**ZONING AMENDMENT,
PLANNED UNIT DEVELOPMENT &
SUBDIVISION STAFF REPORT****Date: August 5, 2013**

<u>NAME</u>	Stratford, L.L.C.
<u>SUBDIVISION NAME</u>	Grelot Office Park Subdivision
<u>LOCATION</u>	North side of Grelot Road, 475'± East of Somerby Drive
<u>CITY COUNCIL DISTRICT</u>	District 6
<u>PRESENT ZONING</u>	LB-2, Limited Business District
<u>PROPOSED ZONING</u>	B-3, Community Business District
<u>AREA OF PROPERTY</u>	1 Lot / 3.0± Acres
<u>CONTEMPLATED USE</u>	<p>Rezoning from LB-2, Limited Business District, to B-3, Community Business District, to allow a boat and RV storage facility, Planned Unit Development Approval to amend a previously approved Planned Unit Development to allow shared access between multiple building sites, and Subdivision to create one legal lot of record from two legal lots of record.</p> <p>It should be noted, however, that any use permitted in the proposed district would be allowed at this location if the zoning is changed. Furthermore, the Planning Commission may consider zoning classifications other than that sought by the applicant for this property.</p>

SITE PLAN

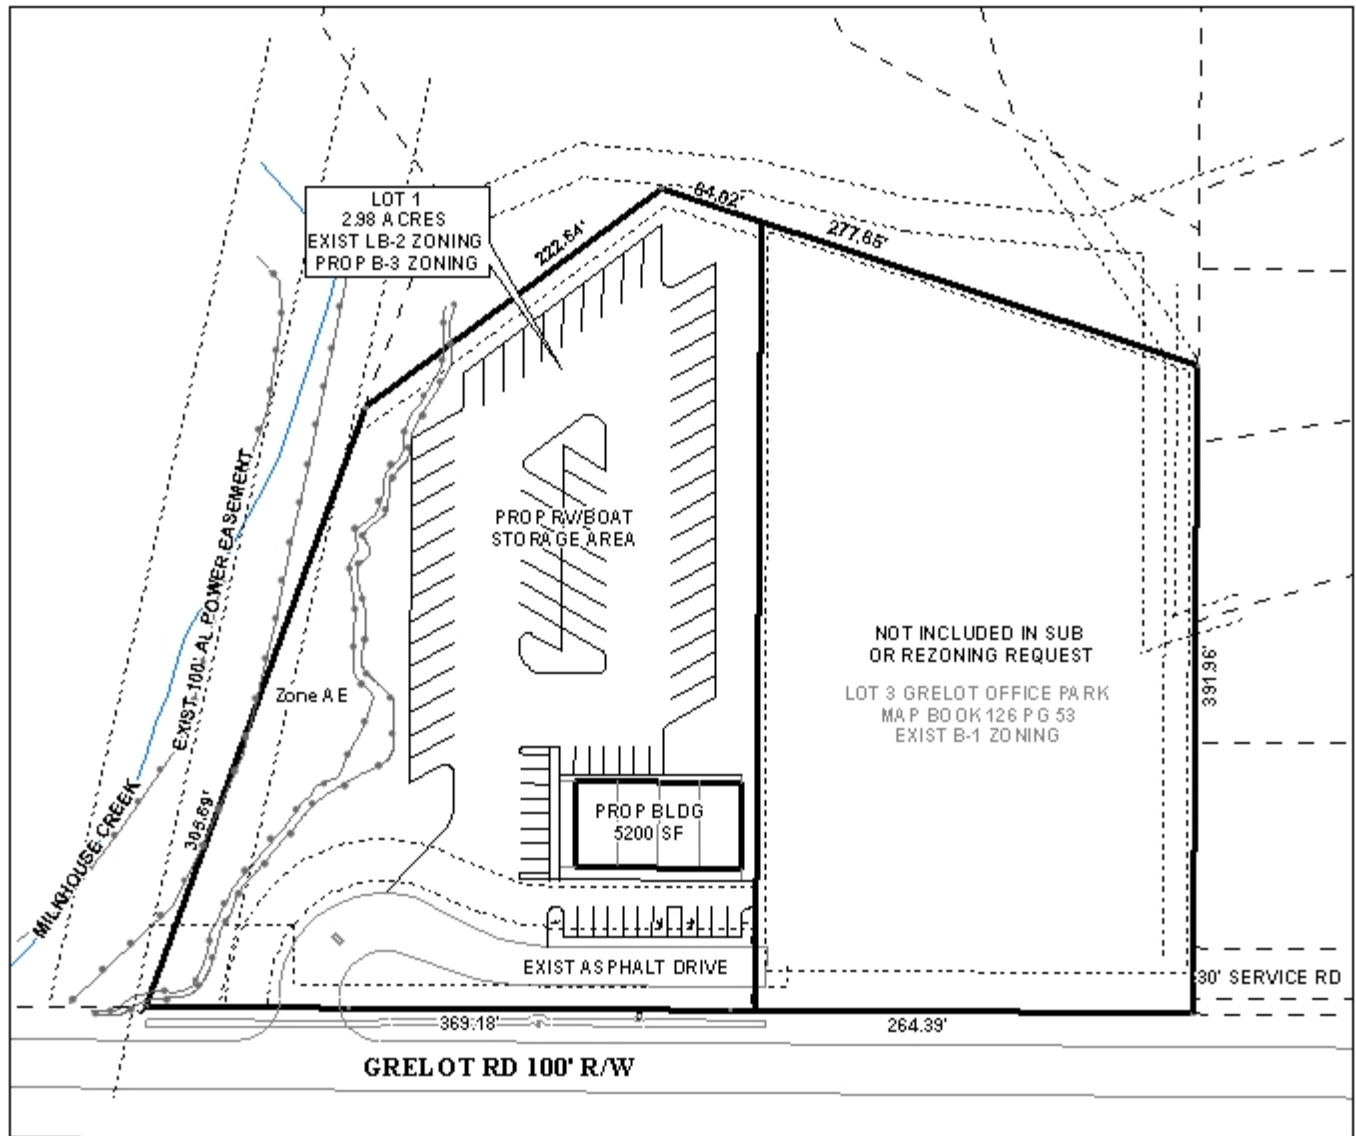
Driveway number, size, location and design to be approved by Traffic Engineering and conform to AASHTO standards. Driving aisle south of proposed building site is illustrated as 15' in width and is inadequate for two-way traffic. The design of the driveway from the easement to Lot 3, while necessary given the proposed nature of the development, may create a traffic issue in the future when Lot 3 is developed. The larger/longer vehicles may enter the driveway from Grelot Road and not be able to successfully stay on the right side of the easement roadway and yield to oncoming traffic from Lot 3 before turning left into Lot 1.

The site plan submitted provides two different scales: 1" = 40' and 1" = 50'. The 1" = 40' scale is accurate, and the 1" = 50' scale should be removed from the site plan, if approved, to avoid confusion. The site plan also contains notes that refer to a non-existent zoning district, "LB-3", and misspell "Zoning Ordinance". It should also be noted that while the legal descriptions

provided on the preliminary plat and the Planned Unit Development site plan are accurate, the legal description given on the Rezoning site plan describes both the proposed Lot 1 and the adjacent Lot 3, when only the proposed Lot 1 should be described. Furthermore, the preliminary plat incorrectly identifies Lot 3 as "Lot 2"; however, as the Subdivision application does not involve this lot, references to it should be removed. These errors should be corrected, if approved.

There is no fence or gate illustrated to access the boat and RV storage area at the rear of the property. If the site will provide fencing to secure the storage area or a gate to access it, the site plan should be revised to illustrate such proposals to insure that the proper number of queuing spaces will be provided between the gate and right-of-way.

There are no dumpsters illustrated on the site plan. The applicant should revise the site plan to provide a dumpster, screened from view and in compliance with Section 64-4.D.9 of the Zoning Ordinance, or place a note that curb side pick-up will be utilized.

The site abuts R-1, Single-Family Residential to the East and North. The site plan illustrates a 20-foot landscape buffer/utility easement along the East. It should be noted that a minimum 10' limited use buffer should be depicted along the North as well as a 6' high privacy fence along the East and North. A note on the proposed site plan stating this requirement should be retained on the site plan and would be required on the Final Plat. The site plan also depicts utility and drainage easements along the East of Lot 3. If approved, a note should be placed on the site plan stating that no structures are allowed in any easements.
